Environmental  
Protection Agency

June 21, 2011

RE: MEDINA COUNTY  
CITY OF WADSWORTH  
VALLEY VIEW ELEMENTARY  
NPDES PERMIT NO. OHC000003  
OHIO EPA PERMIT NO. 3GC05132\*AG  
CONSTRUCTION STORM WATER

Figure 1. The construction entrance is inadequate.

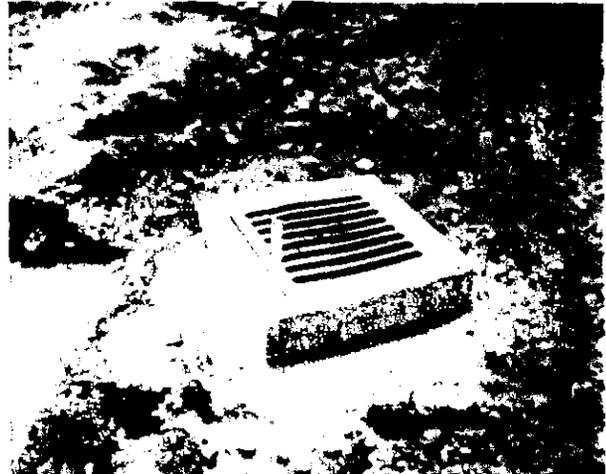
- Offsite tracking of sediment is occurring. A properly designed construction drive must be installed in accordance with the detail drawing depicted in the storm water pollution prevention plan (SWP3) (Figure 1).

Figure 3. Sediment is making its way to an unprotected inlet in the pre-existing elementary school driveway.

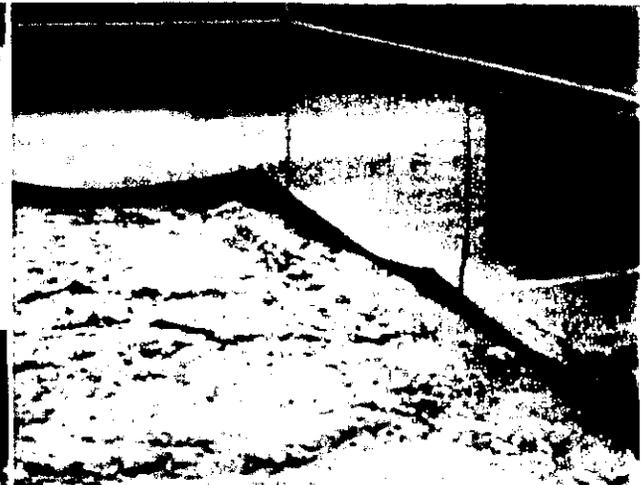
- There are multiple catch basins throughout the site with no inlet protection installed. Inlet protection must be installed to prevent the discharge of sediment-laden runoff to surface waters of the State (Figures 2 to 3), unless the storm sewers lead to the sediment settling pond located in front of the pre-existing school building.
